**VILLAGE OF GERMANTOWN
N112 W17001 MEQUON ROAD
GERMANTOWN, WI 53022**

- A. David Leszczynski, Agent for Germantown Acquisitions LLC, Property Owner, 29.7 acres at W124 N11749 Wasaukee Road (Tax Parcel ID# 241-999); Preliminary Subdivision Plat for a 16-lot single-family residential development (Woodland Ponds Estates)

Village Planner Report

David Leszczynski, agent for Germantown Acquisitions LLC, property owner, is requesting approval of a preliminary subdivision plat for a 16-lot, 29.7-acre single-family residential development called "Woodland Ponds Estates" located north of Elm Lane and west of Wasaukee Road.

ACCESS TO LOT 8 – WOODLAND PONDS ADD. NO. 1

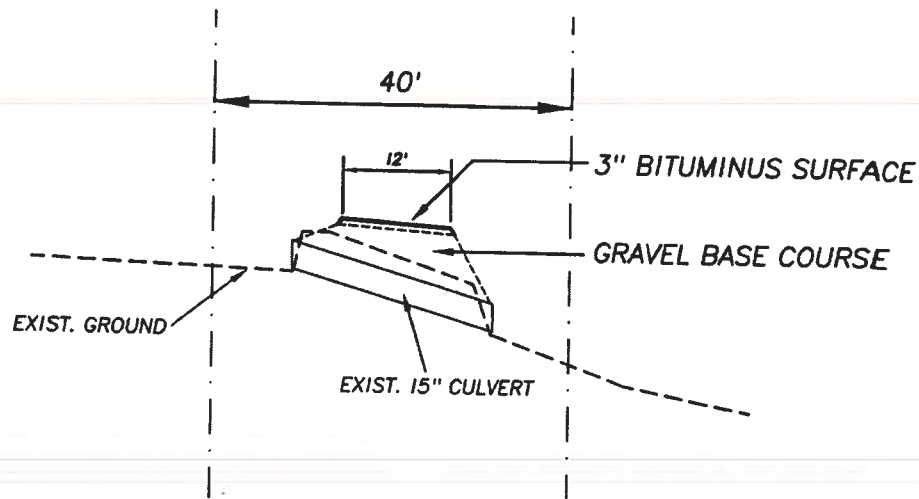
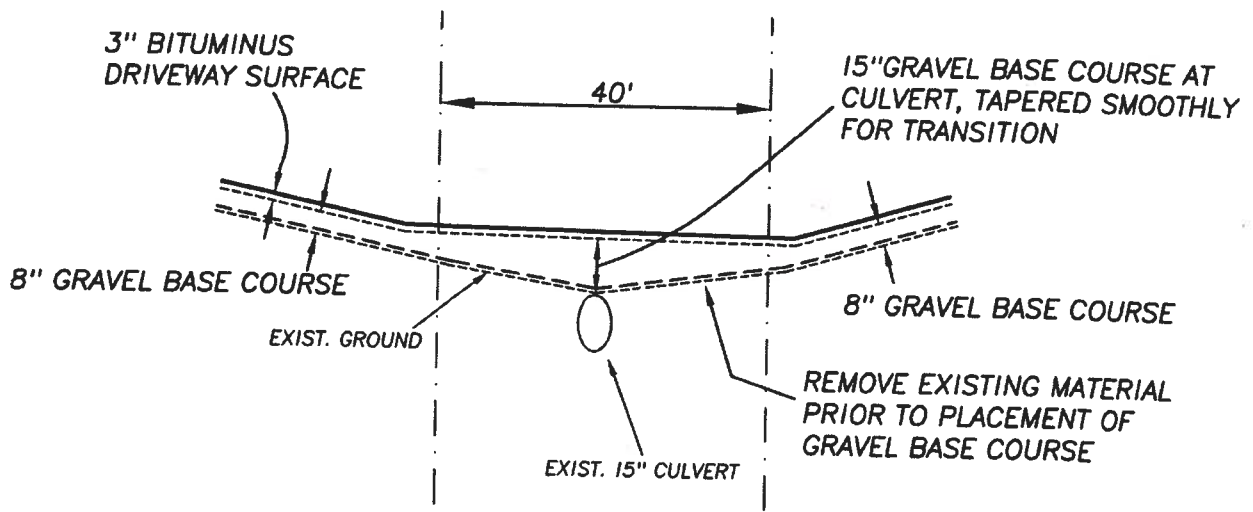
While current FEMA floodplain maps do not show any portion of the property located within the 100-year floodplain, the Village Engineer is concerned that Lots 8 and 9 could be in-accessible during a heavy storm event given the small 15" diameter culvert under the driveway across the wetland. If the 15" culvert creates this problem, replacing the existing 15" culvert with a larger diameter culvert would likely be the solution. However, staff acknowledges that replacing the existing 15" culvert with a larger diameter culvert may trigger the need for additional WisDNR permitting (i.e. an individual fill permit may be required vs. the current general permit approval granted by WisDNR for the 304 sqft fill required just to replace the existing 15" culvert).

If the developer is unable to provide proof that the shared driveway would not be under water in a flood event, staff recommends that the preliminary plat be approved with a condition that stipulates Lots 8 and 9 cannot be included as part of a final plat nor allowed to be develop until and unless said proof is provided and, if necessary, additional WisDNR permitting is required in order to replace the existing 15" culvert with a larger diameter culvert.

7. If the developer is unable to provide proof that the shared driveway would not be under water in a flood event, the preliminary plat be approved with a notation on the face of the plat that stipulates Lot 8 and Lot 9 cannot be included in a final plat nor allowed to be developed unless and until adequate proof is provided to and approved by the Village Engineer.

8. If additional WisDNR permitting is required in order to replace the existing 15" culvert with a larger diameter culvert for any reason, Lot 8 and Lot 9 cannot be included in a final plat nor allowed to be developed unless and until said WisDNR permitting has been approved.

VILLAGE OF GERMANTOWN			
WASHINGTON COUNTY		WISCONSIN	
Woodland Ponds Addition No. 1			
Street tree & Seeding Plan			
DESIGNED: JAK	DRAWN: JAK	CHECKED: JAK	SHEET 1
DATE: 10/9/18	SCALE: 1"=40'		
APPROVED:	PROJECT: LS-4315

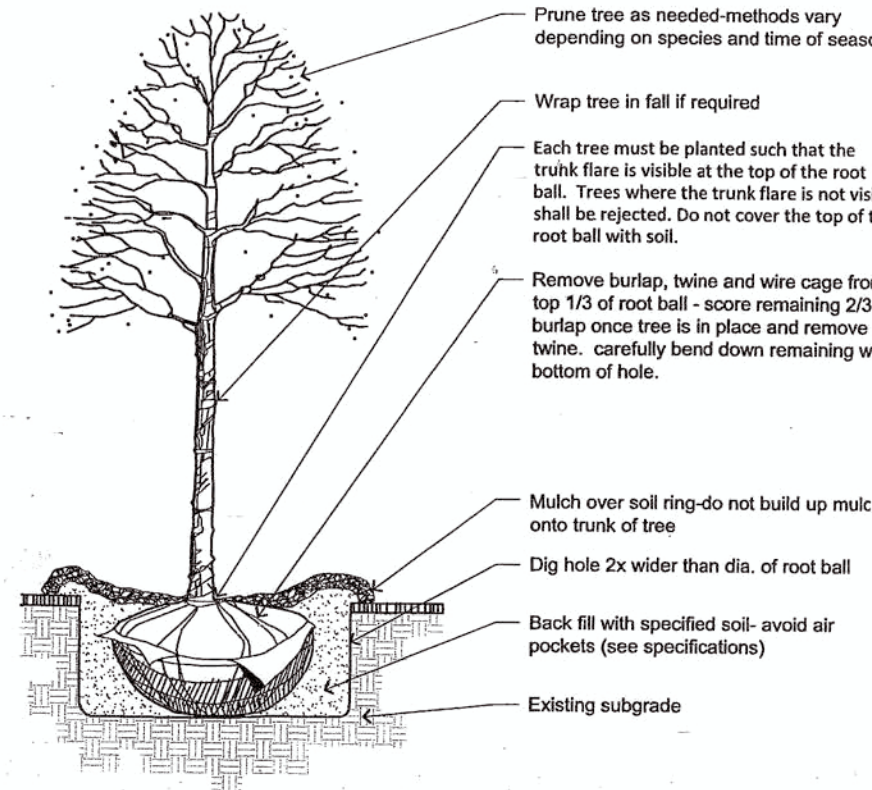
The proposed landscaping plan is limited to the installation of street trees along the extension of Forest Hill Road. The plan needs to also include street trees on the cul-de-sacs and Wasaukee Road. At the time of this writing, the Developer has committed to revising the landscape plan to incorporate the additional street trees around the Taylor Trail cul-de-sac and along Wasaukee Road. Also, the street tree landscape plan needs final approval from the Village Forester. With all of the proposed streets having a rural cross-section (open ditches vs. curb & gutter), the final location of street trees will need to be installed close to the front/street yard property line on each lot. With some of the lots having narrow street frontage, location and installation may need to be coordinated at the time a building permit is issued to avoid the need to re-locate once driveway locations are determined. No subdivision monument sign is proposed.

2. The street tree landscape plan dated October 9, 2018 shall be approved by the Village Forester prior to installation of any street trees within the development. Street trees shall be installed close to the front/street yard property line. The timing of installation of the street trees and common open space landscaping shall be determined as set forth in the Development Agreement. The Developer shall revise the landscape plan to incorporate additional street trees required on the Taylor Trail cul-de-sac and Wasaukee Road.

5. Preliminary plat approval is subject to receipt of a "non-objection" letter from the WI Department of Administration-Plat Review Agency.
6. The Developer shall revise the landscape plan to incorporate additional street trees required on the Taylor Trail cul-de-sac and Wasaukee Road. Final approval of the street tree landscape plan shall be granted by the Village Forester prior to installation of said street trees.
